OP7100 and OP7200 LCD Controller Chips — Library Changes to Support New Chips

Introduction

Figure 1. How to Identify Pre-2006 OP7100 Boards

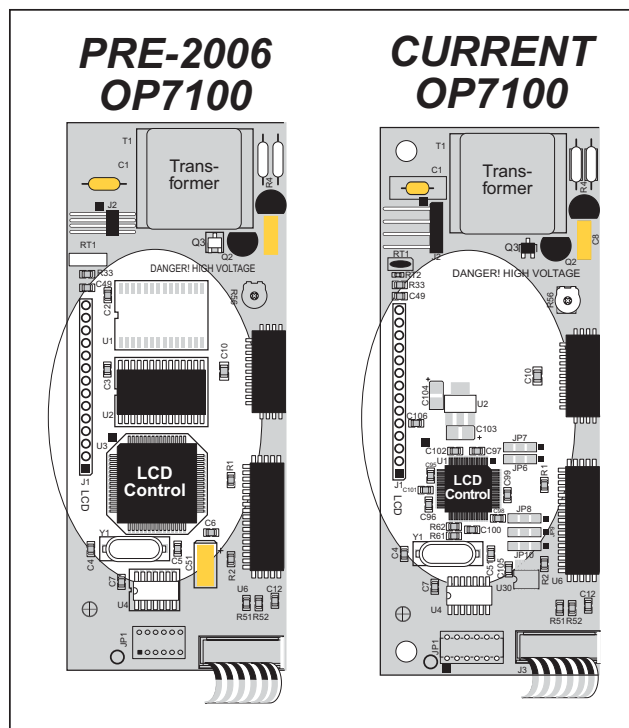
OP7100 units sold after June, 2006, and OP7200 units sold after January, 2006, have a new LCD controller chip because the previously used LCD controller chip is no longer available. The new LCD controller chip has 32K of internal SRAM.

Figure 1 shows the area of the OP7100 that changed to accommodate the new LCD controller chip.

If you are using a program developed for the now-obsolete LCD controller chip, you will need to replace either the existing Dynamic C **OP71L.LIB**, **OP71P.LIB**, and **OP71HW.LIB** libraries or the **LQVGA.LIB** and **PQVGA.LIB** libraries in your Dynamic C installation — you only have to replace one of these two sets of libraries, depending on which set you used when you created your original application. You may, of course, replace all five libraries, which will allow you to access the other updated set at a later date.

The changes to the libraries will improve the OP7100 screen update time for OP7100 units using the new LCD controller chip. Otherwise, the form, fit, and function of the OP7100 are not affected by the changes.

Figure 2. How to Identify Pre-2006 OP7200 Boards

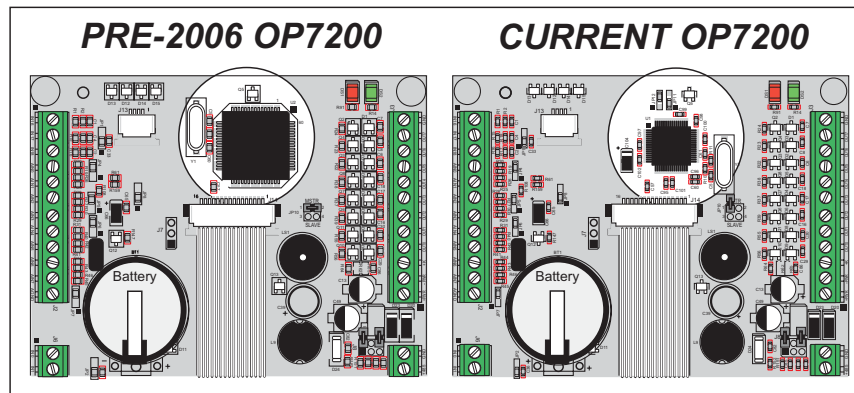
Figure 2 shows the area of the OP7200 that changed to accommodate the new LCD controller chip.

If you are using a program developed with an earlier version of Dynamic C, you will need to replace the existing Dynamic C **SED1335F.LIB** library in your Dynamic C installation in the **LIB\DISPLAYS\GRAPHIC\320x240** folder. Once you have the new **SED1335F.LIB** library, you will have to recompile your program.

The changes to the **SED1335F.LIB** library will improve the OP7200 screen update time by a factor of four. Otherwise, the form, fit, and function of the OP7200 are not affected by the changes.
